SERVICE BULLETIN

Subject: Liberated Head of Tubular Rivet PN 800162WE, installed in JT8D Engine 7th Stage High Pressure Compressor (HPC), (reference SIL 130418-001, dated 4/18/2013).

Service Bulletin No: 130617-001
 Page 1 of 4

Figure 1, Rivet ISO View & Section View of Installed Rivet

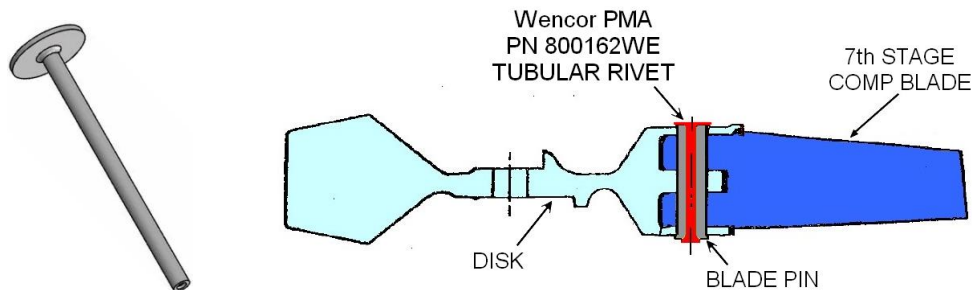
Between January and July 2013, two customers have discovered a total of 13 Wencor Tubular Rivets that had liberated the rivet head after an unknown time in service. The rivets were installed in the 7th stage HPC section of JT8D series engines, and were assembled between January 2011 thru December 2011. On 9 engines a single rivet head out of 60 total rivets was found missing and on 2 engines two rivet heads were found missing. No engine related failures or detectable loss of performance in engine operation has been caused by the failed (liberated head) rivets at any customer.

The function of the Wencor Tubular Rivet PN 800162WE is to prevent forward axial movement of the 7th stage HPC blade pin.

Loss of the rivet head could allow the affected 7th stage blade pin to move forward out of the 7th stage disk. Due to the blade-to-disk retention design, the blade pin would need to move forward at least half the length of the blade pin before the 7th stage blade could be liberated due to fracture of the disk rail. A liberated 7th stage blade would result in an engine shut down.

Figure 2: Wencor Rivets with Marking on Rivet Head

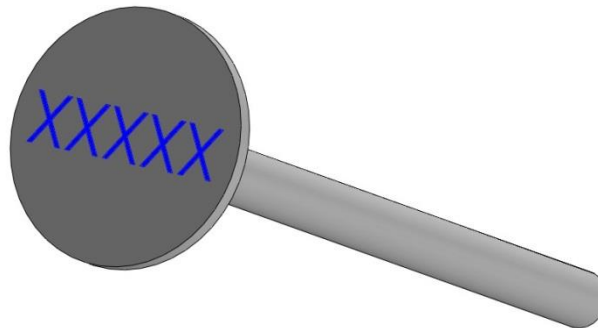
The repetitive borescope inspection may cease when all Wencor rivets that do not have any marking on the rivet head as shown below in Figure 2 have been removed from service. Rivets with marking on the rivet head have been inspected for cracks under the rivet head and screened for proper manufacturing.
